PLANNING & ZONING COMMISSION

Wednesday, May 18, 2022, 10:00 AM

- B. **Request for Site Plan; Bristol Park Apartments** (Project Name); 19510 US 4541(Site Address) Limit Ave (South) US Hwy 441 (North East) (Location); Cagan Management Group, Inc. (Applicant); Wicks Engineering Services, Inc. (Engineer); L.R. Huffstetler, Inc. (Landscape Architect); Forum Architecture & Interior Design (Architect). Project No. SP22-03.

BRISTOL PARK APARTMENTS
 COVER SHEET
 MOUNT DORA, FLORIDA 34736

Drawn: WSR	REVISION:	DATE:
Checked: KRW	1 COUNTY COMMENTS	03-18-22
Date: 03-04-22		
Scale: AS SHOWN		
File No.: 19123		
Sheet: 15 of 32

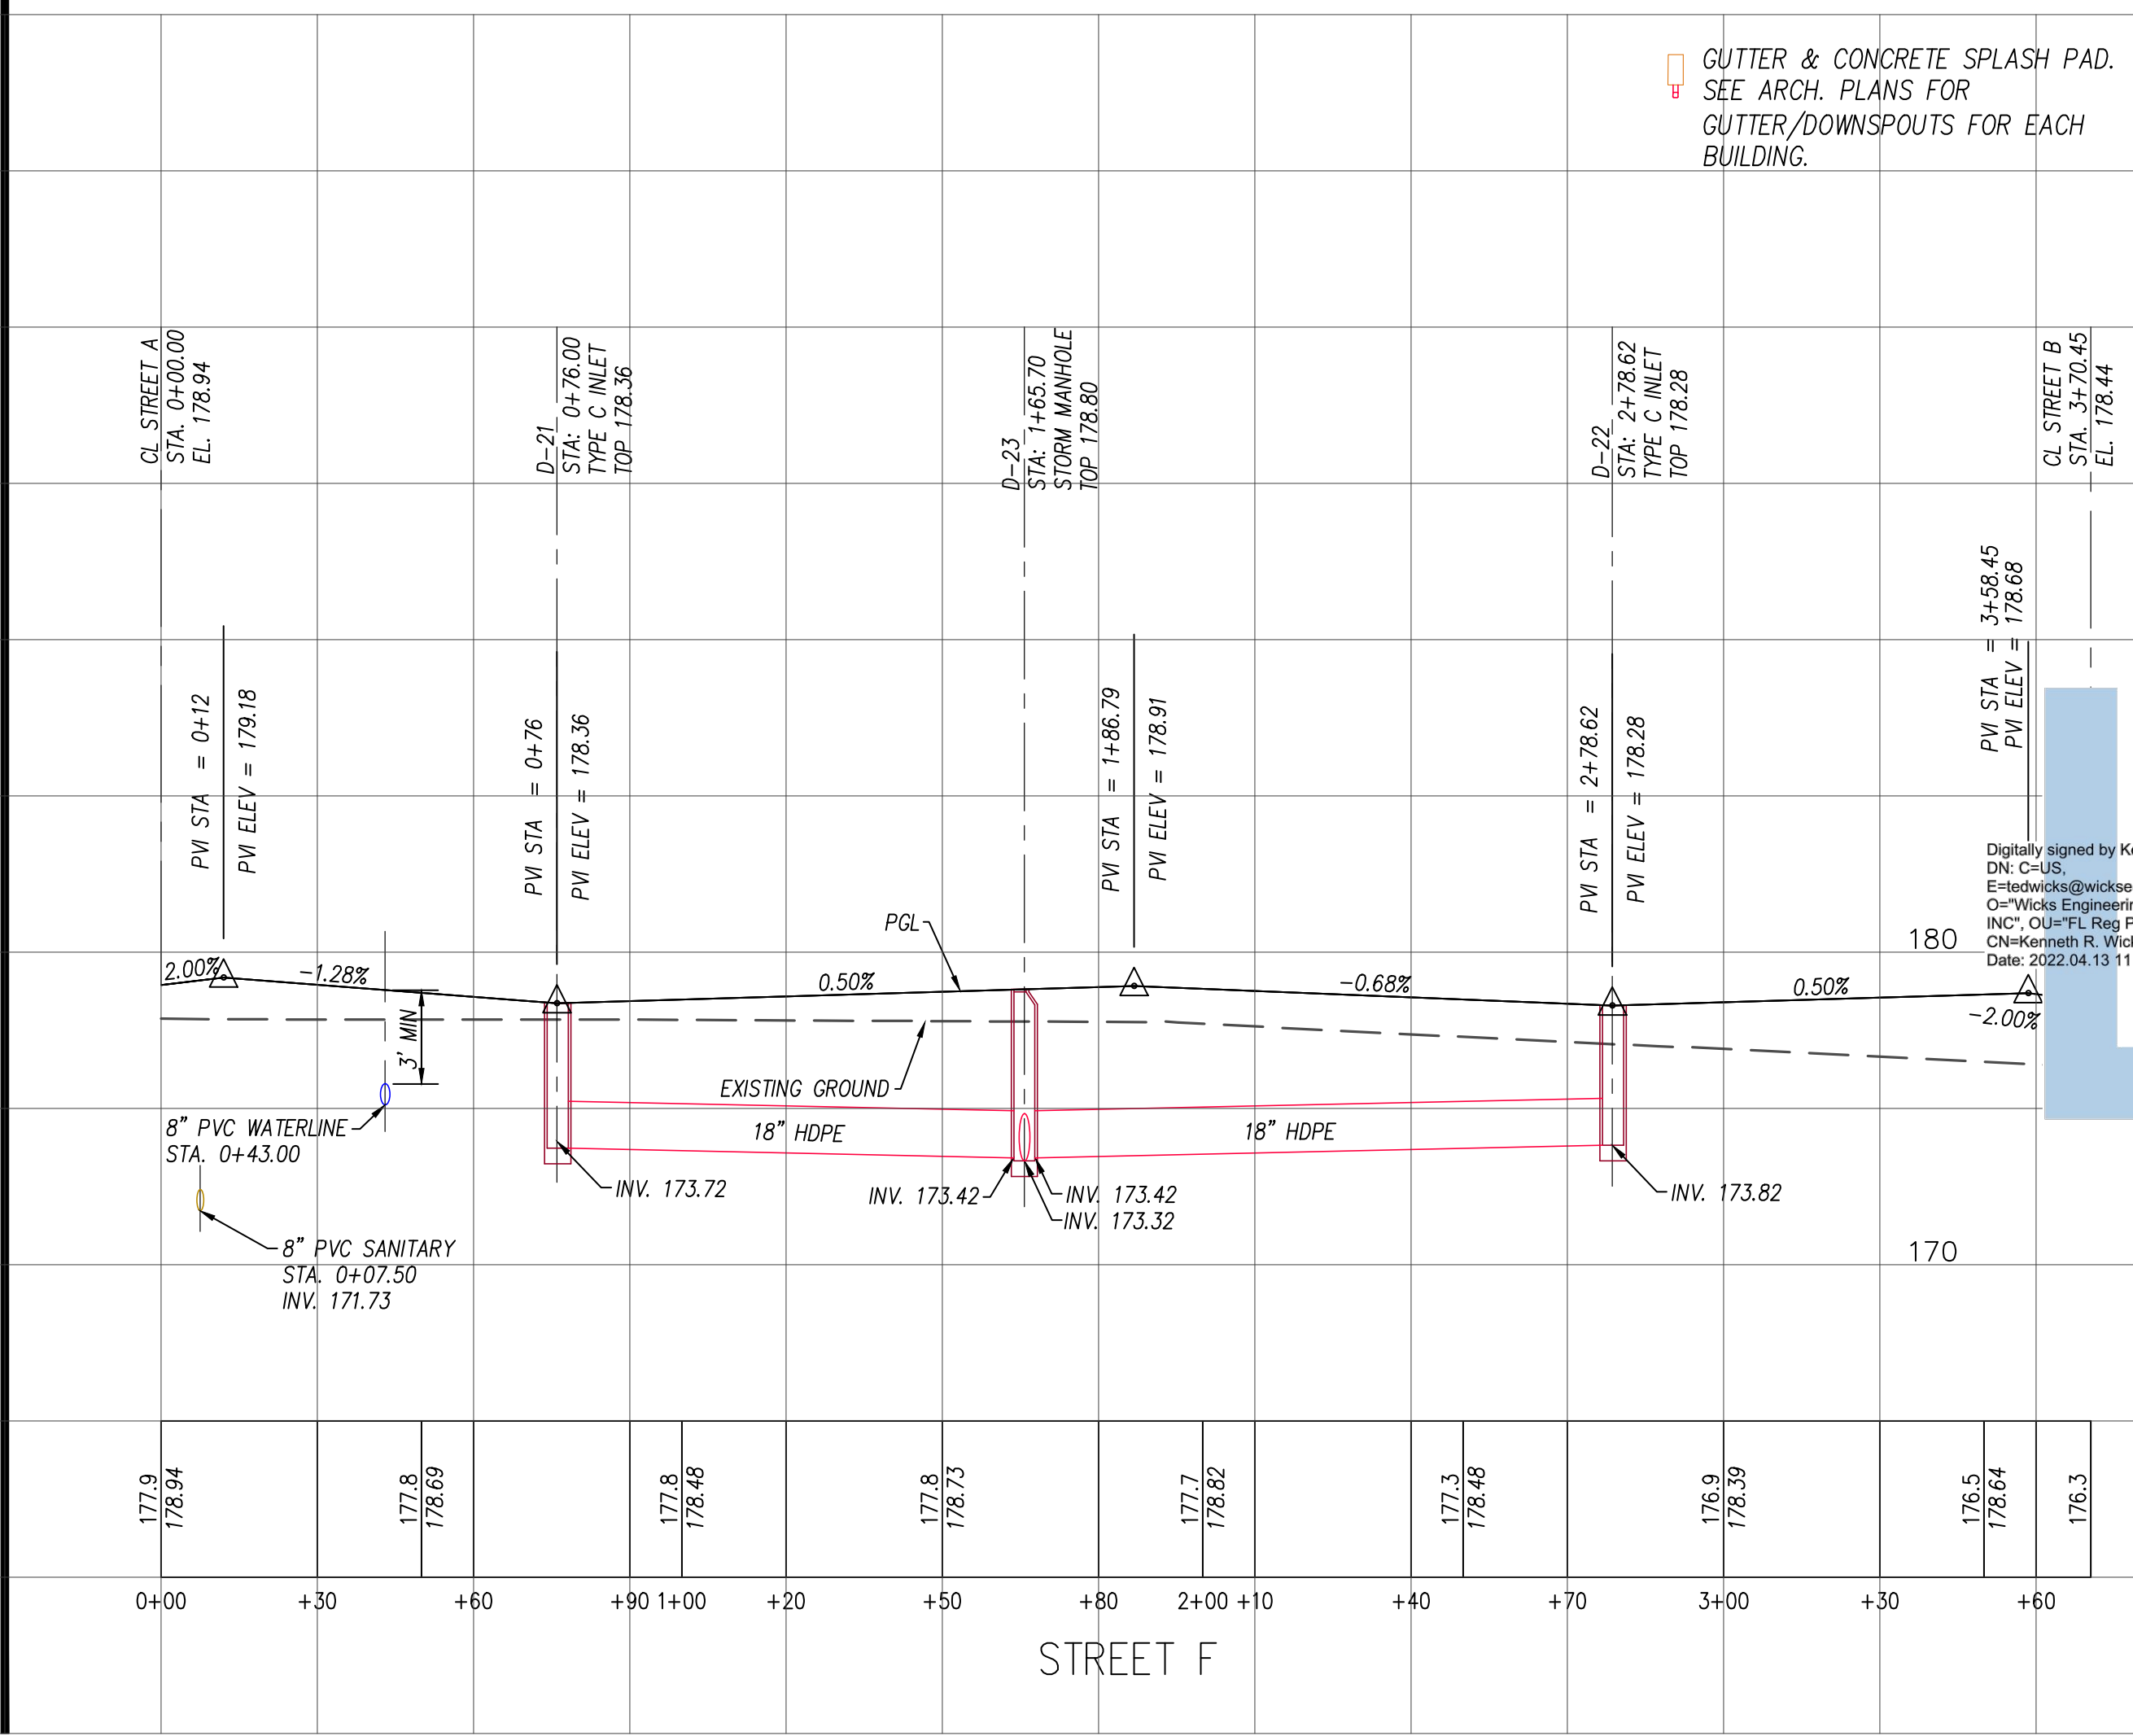
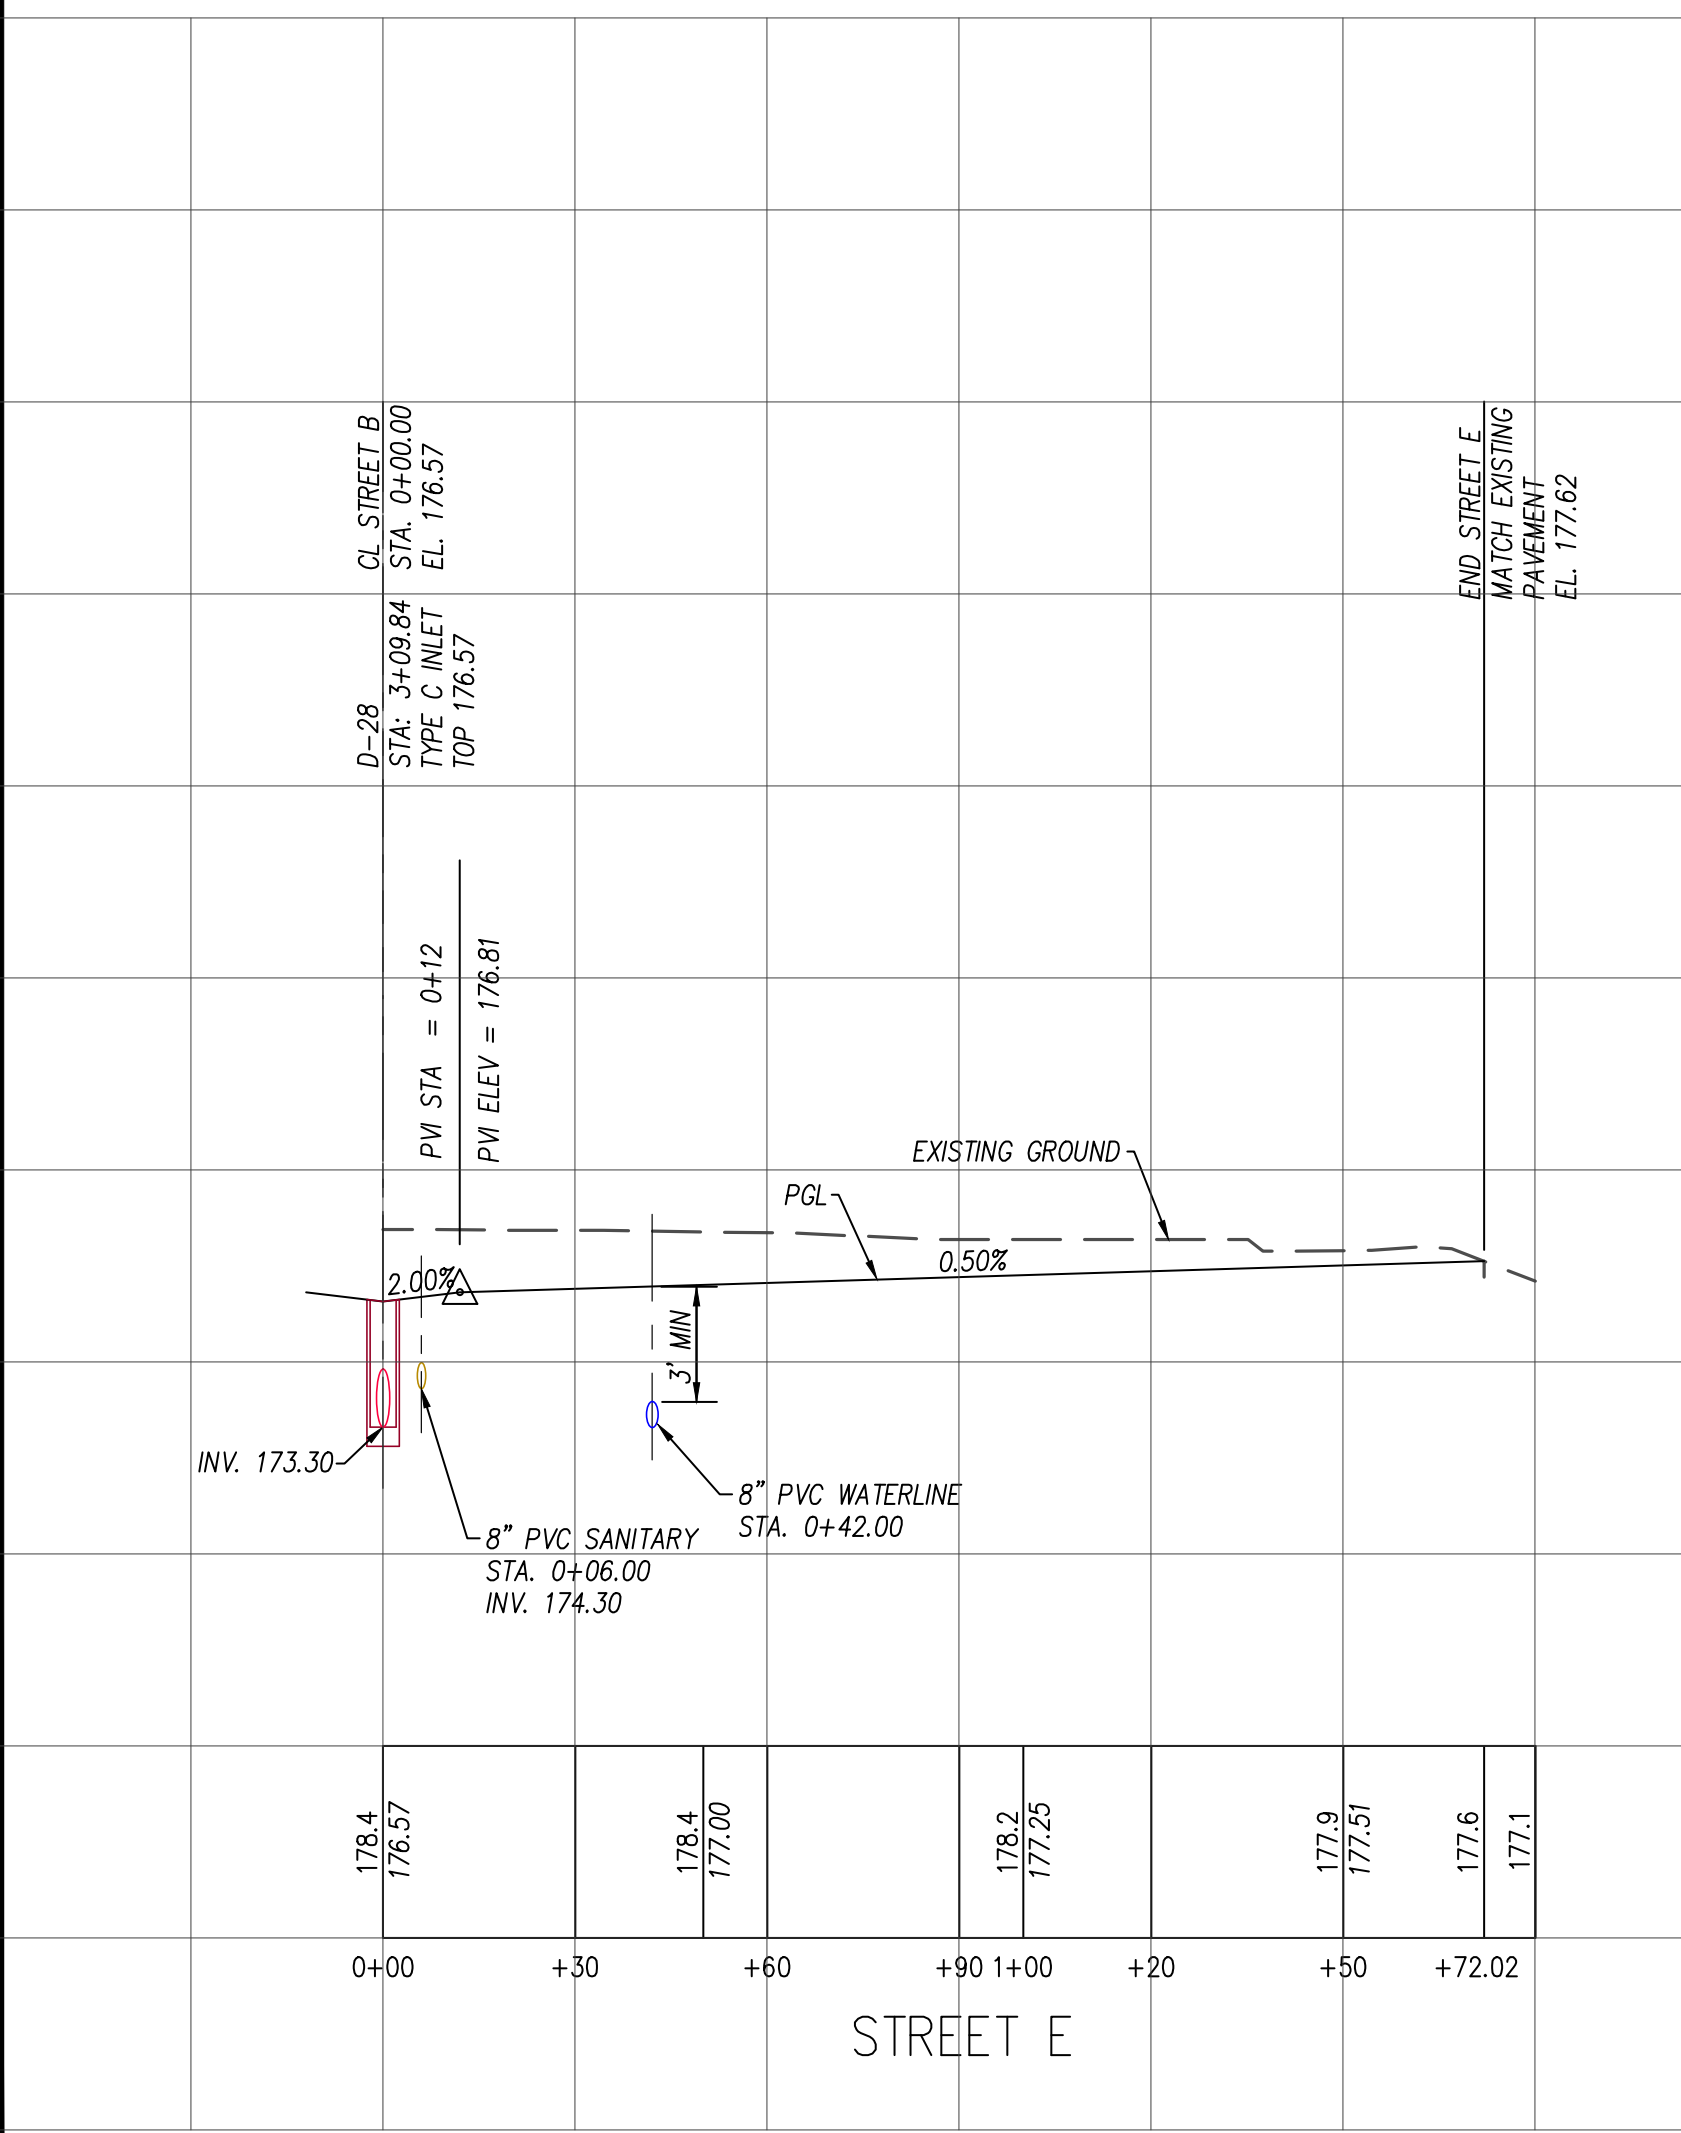
82. Sheet 15 of 32 – in the left hand profile view the water is shown to be at the same elevation as the sanitary sewer. Please correct with appropriate separation distances.
